**Amendments to the Drawings:**

## **Remarks**

FIG. 3

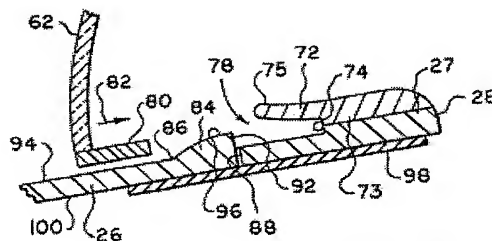
The displacement of the lock element and the screen with respect to the mask occurs once the shield is brought closer to the mask and the movement is directed **away** from the user's face, along the upper ridge of the mask shell that covers the user's nose, i.e., it is substantially along the upper bridge of the user's nose. In other words, the engagement begins closer to the user's face and moves outwardly. The incline is from the top and inside of the mask toward the bottom and outside of the mask, i.e., from the user toward the space in front of the user, i.e., **away from the mask**. The sliding component of the attaching is **outwardly sloping away from the user's face**; note the outwardly sideways slope of Figure 3 shown above.

FIG. 8

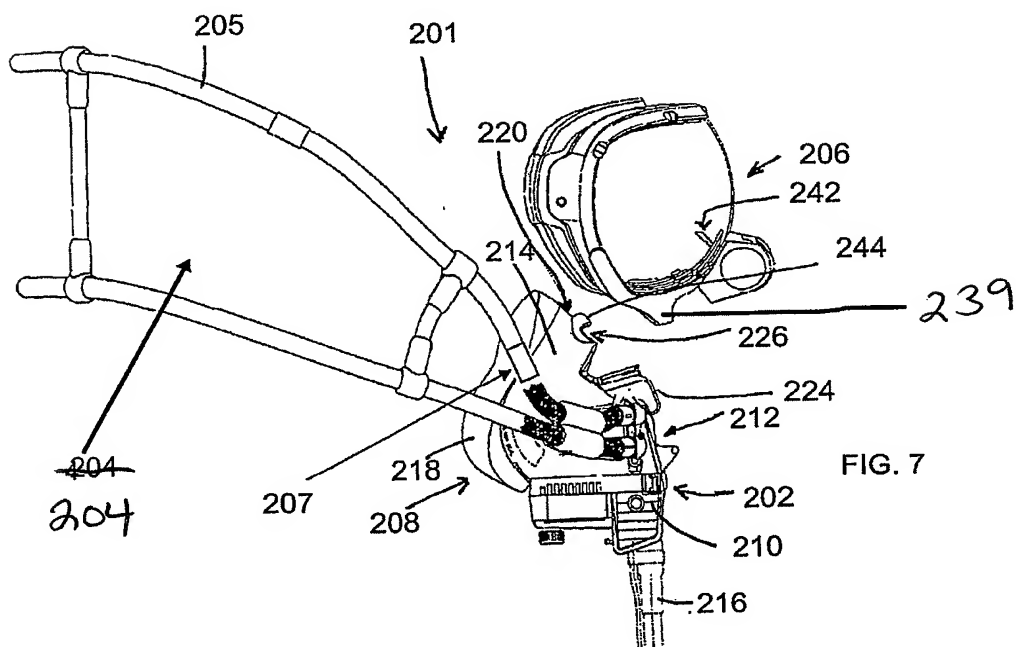
The attached sheets of replacement drawings replace all original sheets. These replacement figures are larger than those originally filed in order to better show the claimed structures, as requested by the Examiner. Reference numeral "1" has been added to Figure 1. Reference numerals 239 and 250 have been added to figures 7, 8, and 12. The shading has been removed from figures 13 and 15. No new matter has been added.
